From: Colin King [REDACTED]
Sent: 28 September 2020 21:28
To: Norfolk Boreas <NorfolkBoreas@planninginspectorate.gov.uk>
Subject: Norfolk Boreas Project EN010087.

Applicant's Comments on Deadline 15 Submissions.
Regarding the Rochdale Envelope.

This scale diagram shows the 4 converter halls alone of Boreas/Vanguard would be equivalent to 8 Angels of The North.

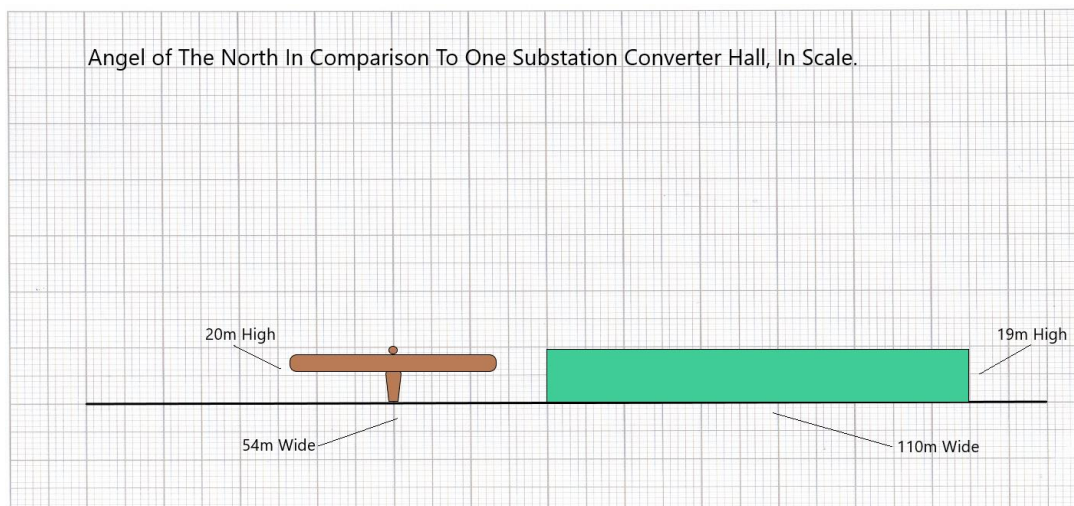
4. This leads on to the question of, total accuracy of the visualisations, taking into account three unconnected computer packages were used to generate the visualisations, and the converter halls placement and scale was verified by using existing landmarks. Taking into account the size of these substations, and how much evaluation was based on the visualisations, the effects of any inaccuracies cannot be overestimated.

If the visualisations are showing a landform in an exaggerated state to provide an acceptable view, does this make a case for bunding to equal the exaggerated land form?
